SUBJECT: Invitation for Bids (IFB) No. 4-2693 for “CNG Fuel Tank Replacement”

This letter serves as Addendum No. 1 to the above IFB issued by the Orange County Transportation Authority (OCTA). This Addendum No. 1 is being issued to:

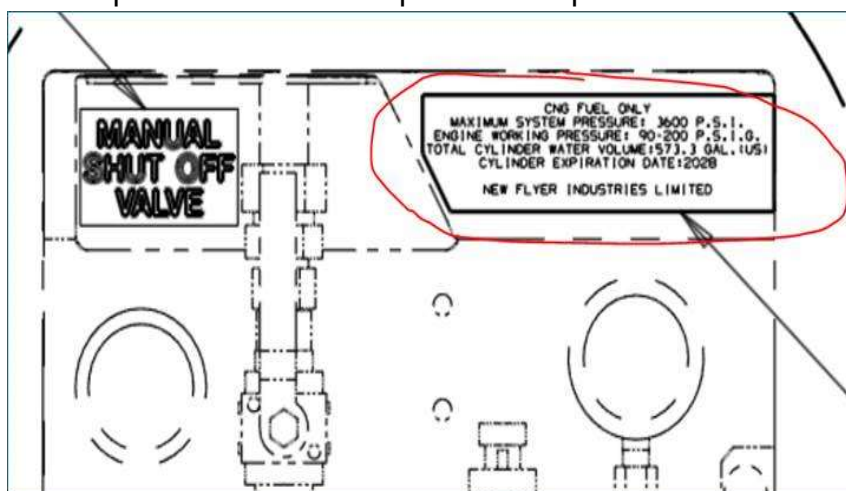
Question 5: Is OCTA aware they will need an updated fuel-fill decal, that represents the latest specs and expiration date?

Response 5: Section III, Scope of Work, will be amended to include tank specifications and inspection decals.

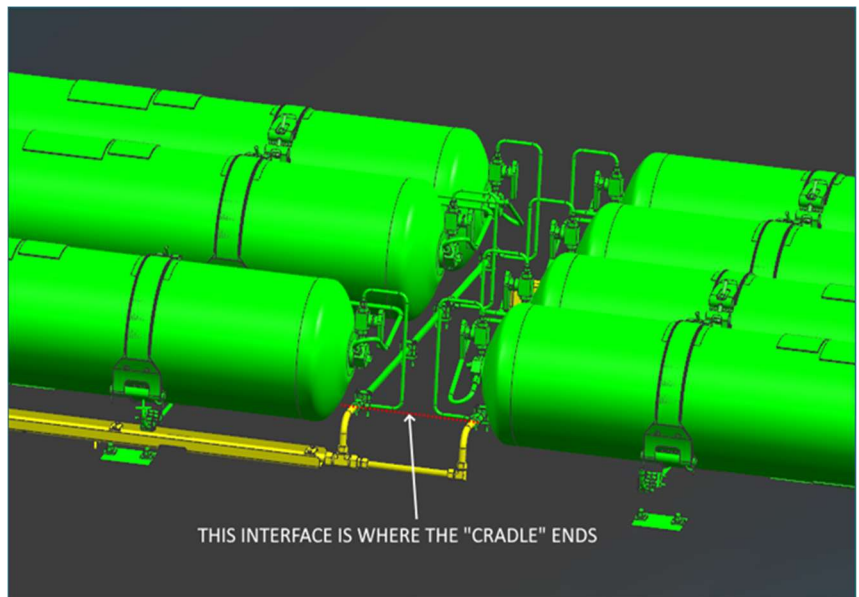
Question 6: The CNG bid is not clear on what constitutes a "cradle." The NFI Parts Engineering interpretation is the tanks, straps, piping, fittings, and valves. It does not include anything beyond the interface with the piping that leads to the engine. So, we do all the green, the yellow remains on the bus. Please confirm this is how OCTA interprets it as well?

Response 6: The yellow elbow should go towards the green side. All other yellow items will remain on the bus.

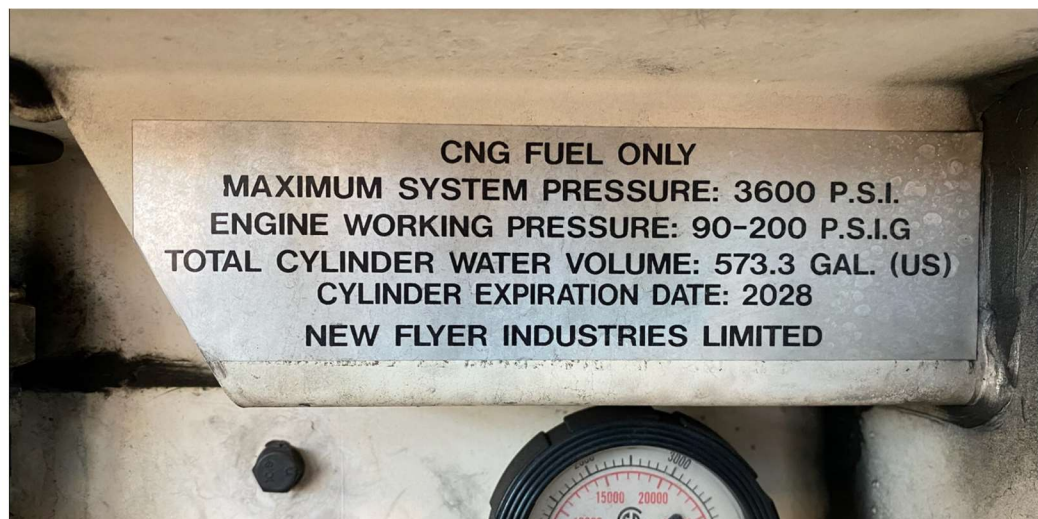
- i. Contractor will provide latest tank specifications and inspection decals. Fuel Tank specification and inspection details can be obtained from fuel tank supplier Hexagon Agility.
- j. Below are some referential pictures of decals:
